**SECTION 00 90 04
BIDDING AND CONTRACT REQUIREMENTS
ADDENDUM NUMBER 4**

Issued: October 12, 2023

Re: ADDENDUM NUMBER (4) TO THE BIDDING DOCUMENTS FOR

**McHenry County College
University Center at MCC**
Architect's Project Number: 22-050

A10.00

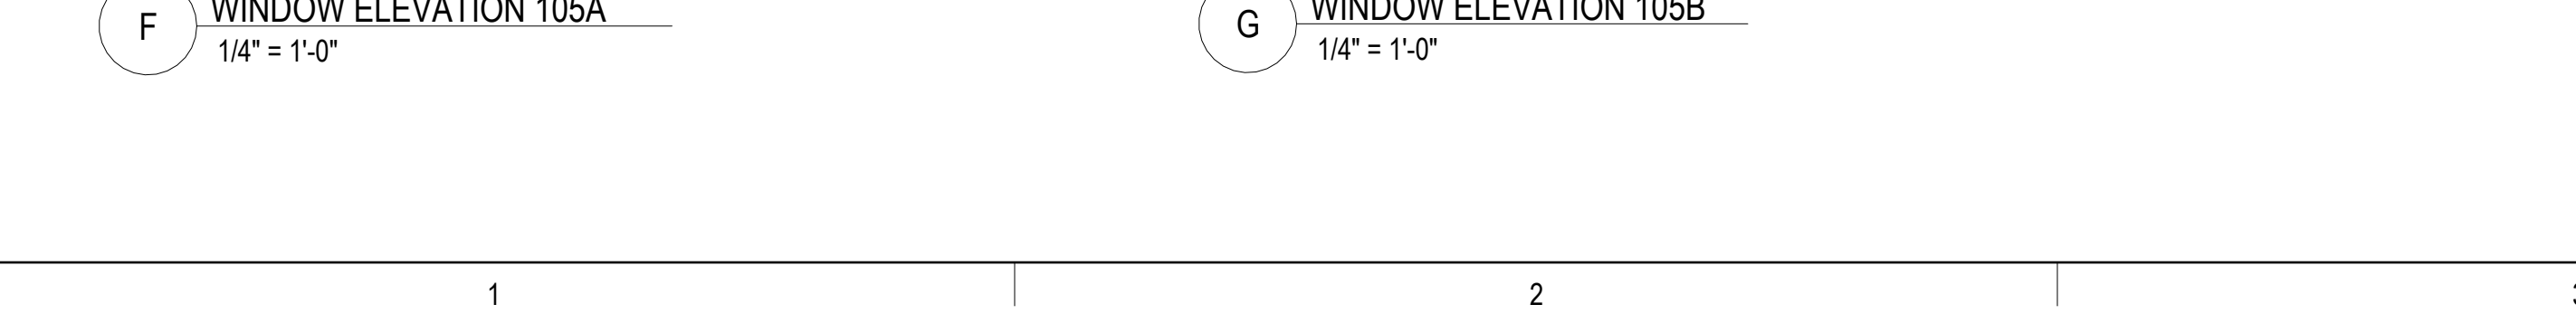
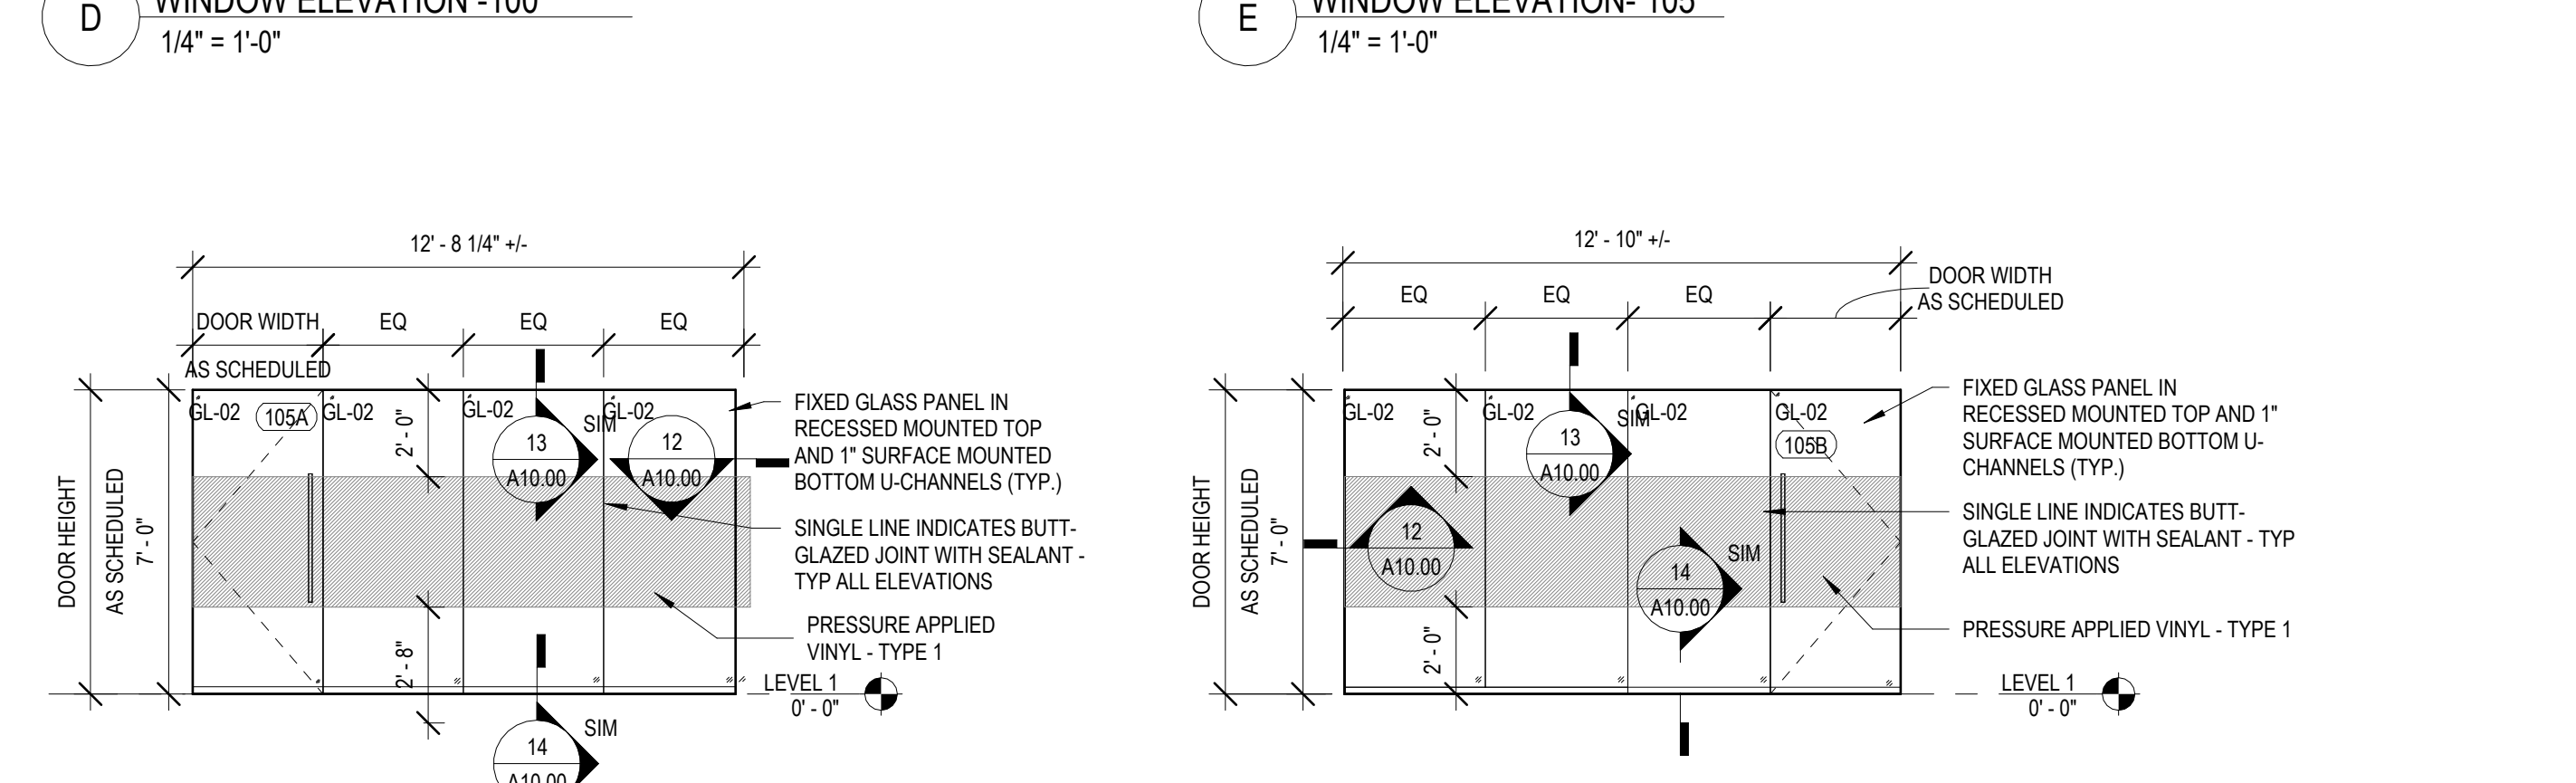
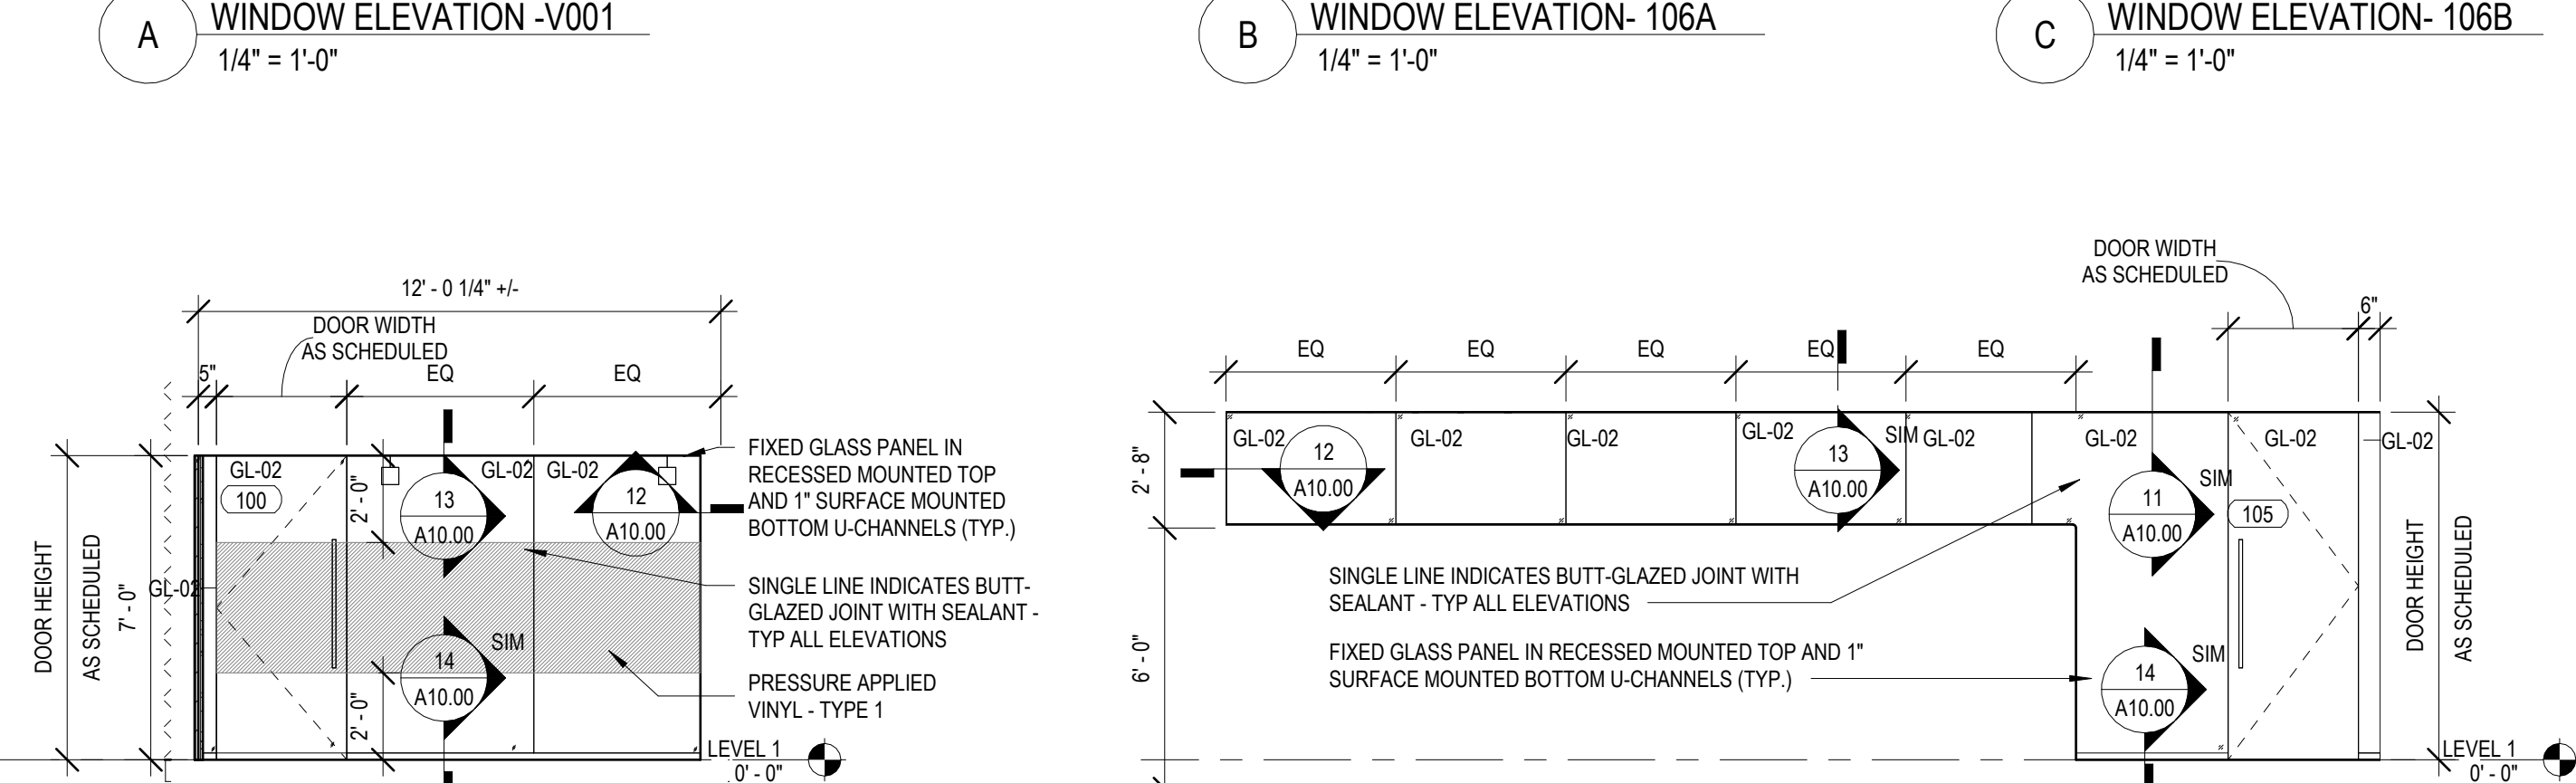
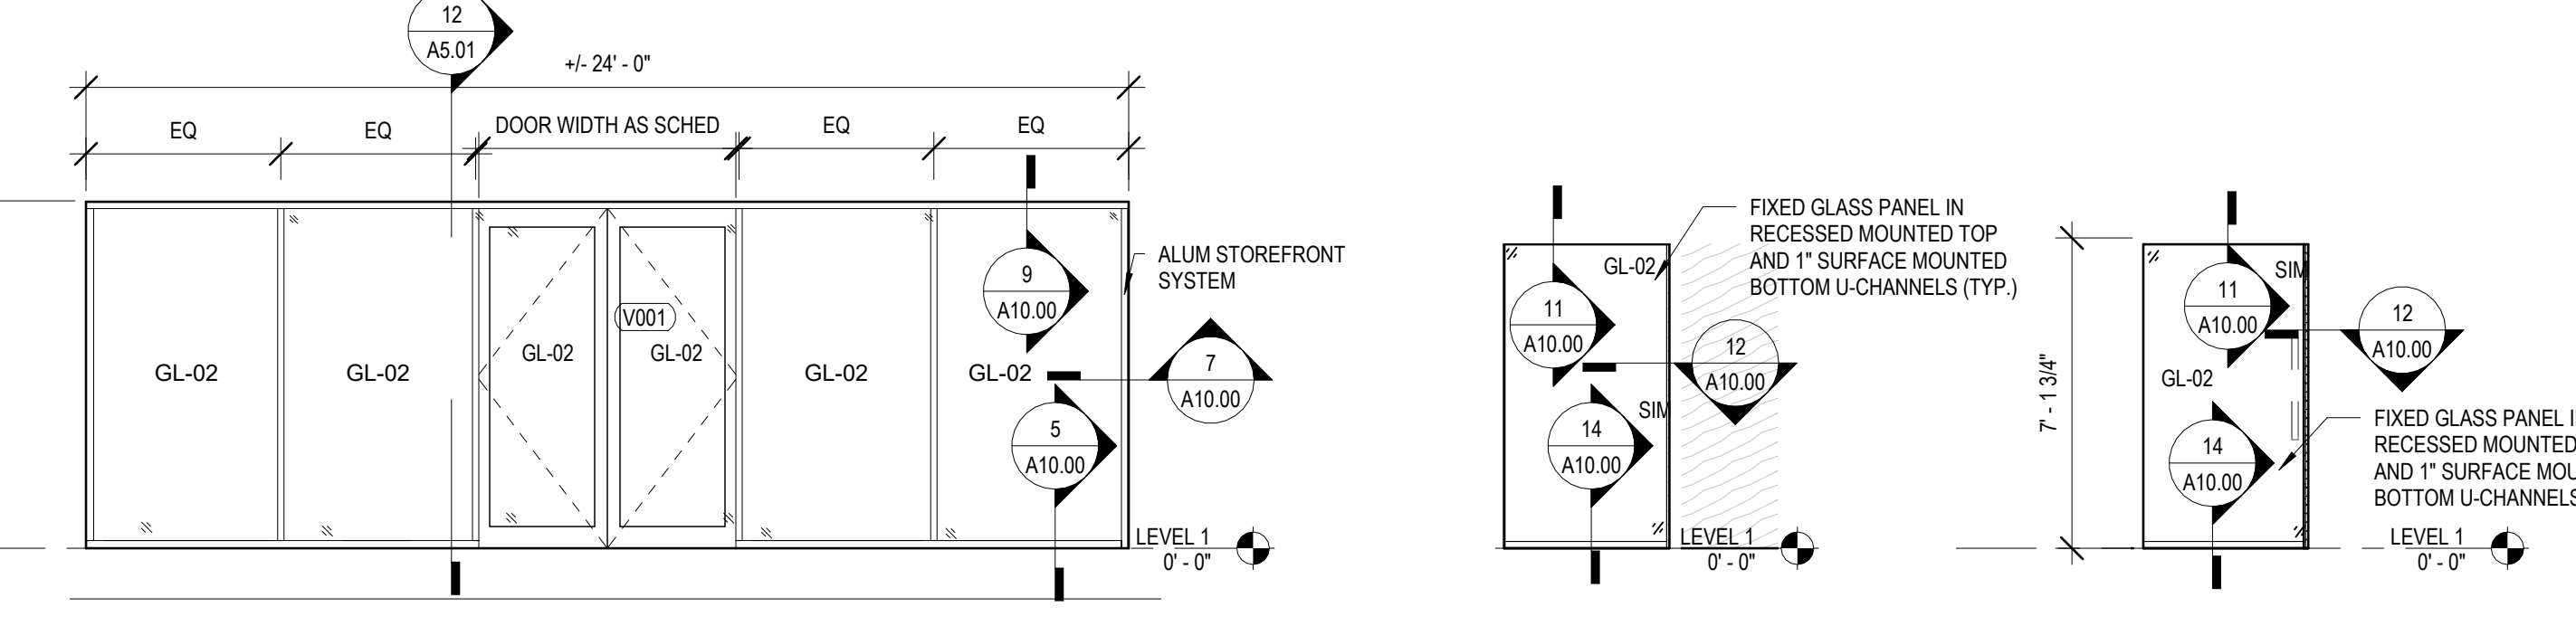
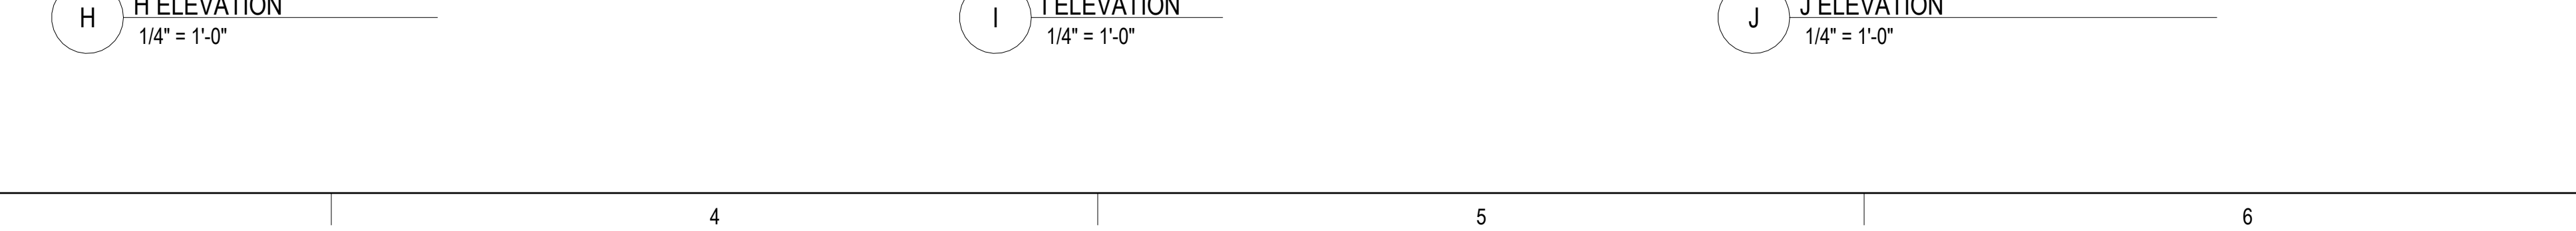
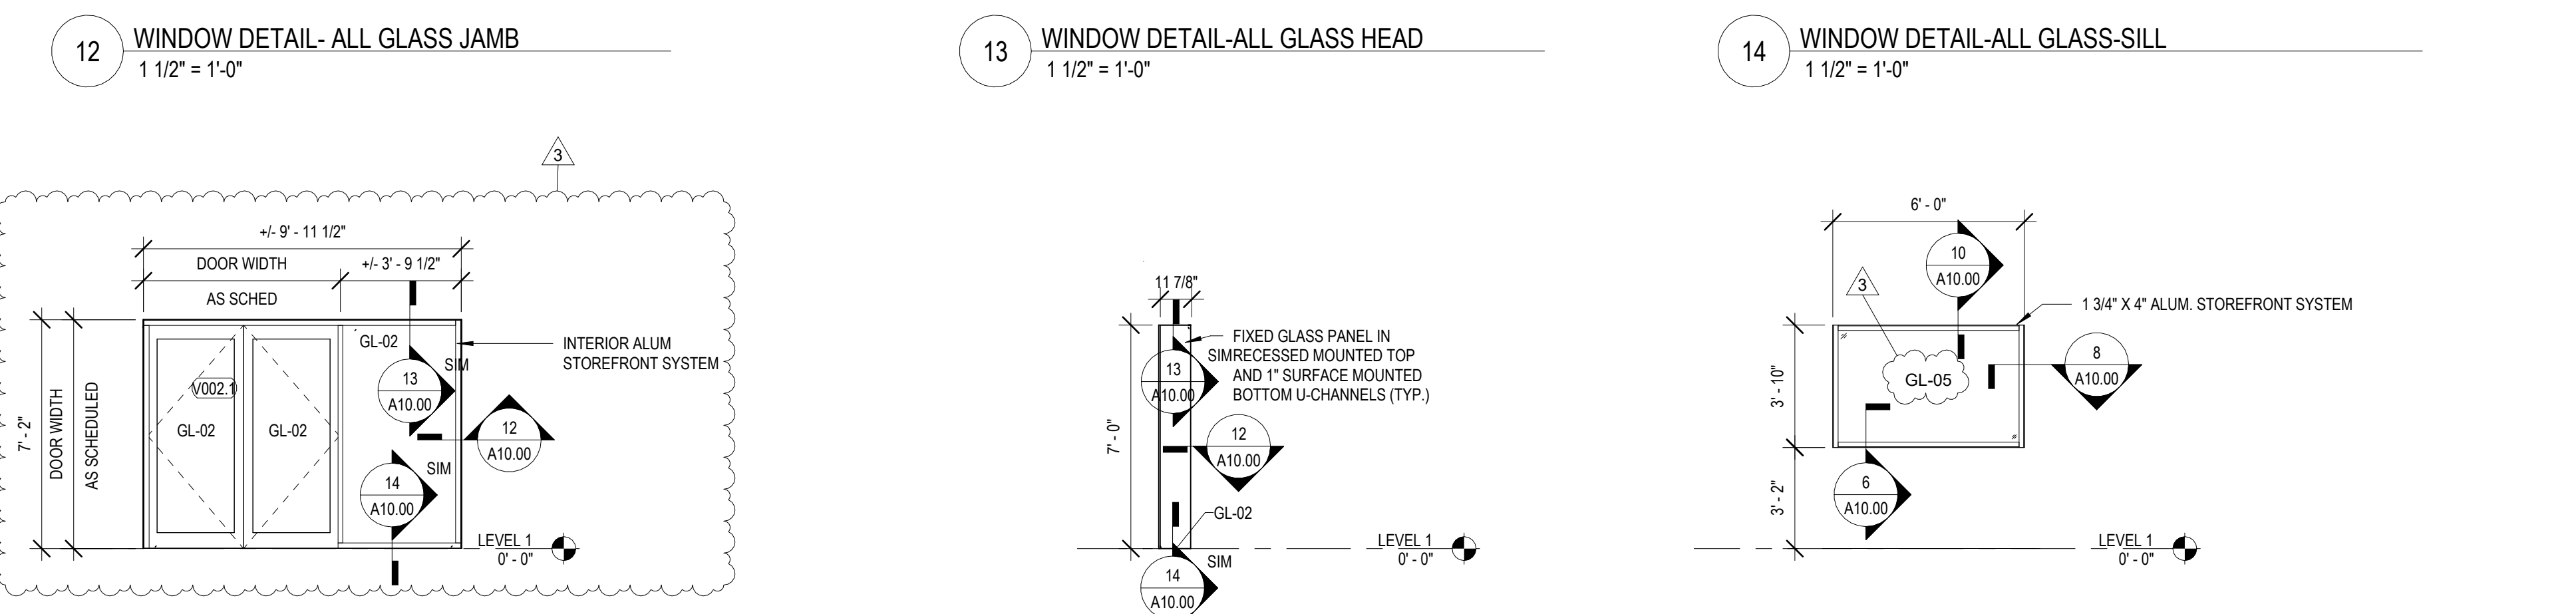
10. A10.00
 - A. **REVISE** window elevation H as indicated.
 - B. **REVISE** door types V001, V002.1, and V002.2 as indicated.
 - C. **REVISE** elevation J glass type to GL-05 as indicated.

027	Frame J on sheet A/10.0 Calls out GL-2 (1/2" clear tempered) the elevation 17/A9.51 calls out one way glass. Which are we to figure?	Provide GI-05 at window elevation J. Refer to Addendum #4.
028	Door # V002.1 &107 are called out as AG and GL-1 (1/4" clear tempered) should this be GL-2?	Yes - This should be GL-02 and was updated in Addendum #3.
029	The door schedule calls out all the door lites in the wood doors and sidelites as GL-2 (1/2" clear tempered) should these be GL-1?	Door vision lites in NFG type doors should be GL-1. All other vision lites and sidelites should be GL-2.
030	Should we figure door V001 as Aluminum FG or All Glass as called out on the door schedule?	Aluminum FG. Refer to Addendum #4 for clarification.
032	Are we to figure the aluminum frames for the wood doors as storefront or are they RACO / Wilson Frames?	Aluminum frames for wood doors will be storefront system single frames to match storefront entrance and window systems.
